Following a site visit on January 11, 2020, I submit the following review of the over-framing ("California framing") portion of the roof for the property per subject line.

Figure 2: Current Roof Plan w/ California Framing

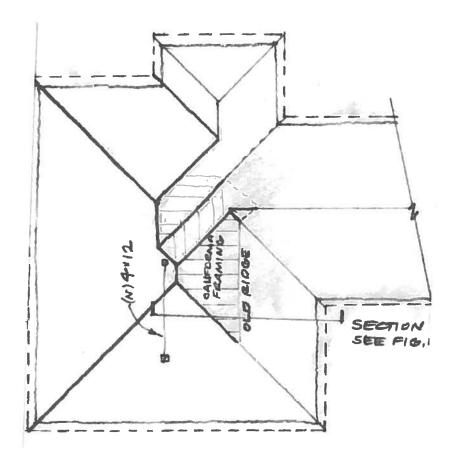
In order to raise the ridgeline of the roof to accommodate the widened ADU addition portion of the house, California framing technique was used, whereby a 2x plate was nailed to the existing roof sheathing and new 2x6 rafters were toe nailed into the plate and extended up to a new higher ridgeline (see Figure 2: Current Roof Plan w/ California Framing). Ridge and valleys are 2x8. The old ridgeline becomes a new purlin line, effectively dividing the span of the new lengthened rafter into two parts with one part original rafter and one part new rafter. The rafters opposite the new purlin line become struts, as defined in CBC 2308.7.7. Thus, the new load path becomes as follows: roofing - (n) rafters - purlin (old ridgeline) - struts (old rafters) - walls or purlins - struts - walls - foundation

Figure 3: (N) 4x12 Calculation

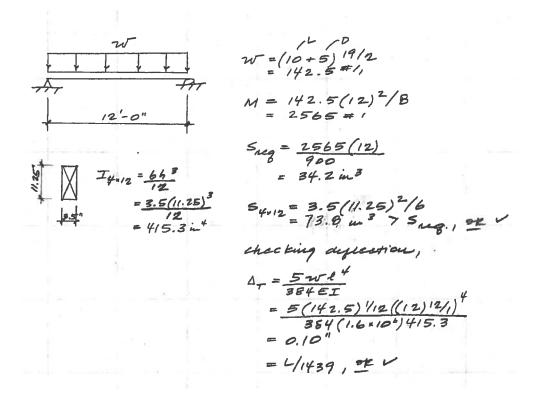
The support line for the original roof closest to the ADU addition changes from a bearing wall to a 4x12 flush-framed beam (see Figure 3: (N) 4x12 Calculation).

Figure 4: Proposed Roof Framing w/ Additional Struts

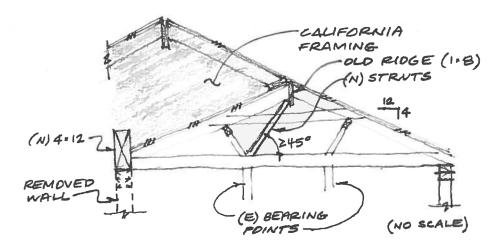
However, since these struts need to be at least 45 degrees from horizontal (CBC 2308.7.7), and they are currently 3:12 (14 degrees), I recommend the introduction of new 2x struts coming down from the old ridgeline to bearing points below at no less than 45 degrees from horizontal. Furthermore, the unbraced length of these struts shall not exceed 8 feet (CBC 2308.7.7).

This will result in a California framed portion of roof that satisfactorily meets the intent of CBC 2308.
